Historical Architectural Review Board

Final Staff Review

HDC-2024-000105

Proposal: Legalization of 3rd floor addition, roof, and siding.

2 WOOD SIDING DETAIL
SCALE: N.T.S.

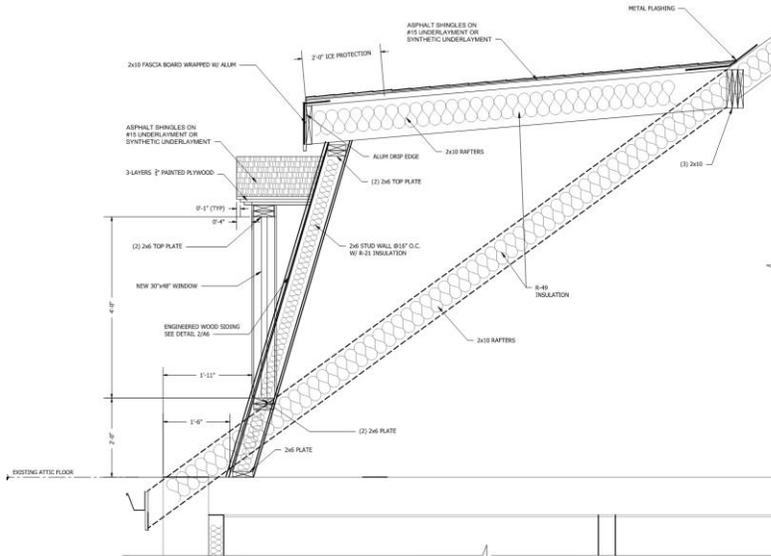
Mr. Huber noted a smooth surface on the siding and a 4-6" exposure on the siding would be more appropriate. The applicant noted he is willing to adjust the siding material to what is more appropriate. Mr. Huber made some detail suggestions to set back the faux mansard vertical (approximately 2'-0") and set back from the dormer windows, which the applicant was willing to adjust.

- The front dormer facing West Chew Street is set back to a minimum 2' from the face of the brick wall and is oriented vertically, not slanted. Windows are set flush with the exterior face of the dormer and trimmed with casings, including pediments and caps as presented.
- Siding on the dormer reveal will be a maximum of 6" and smooth material in keeping with Guidelines.
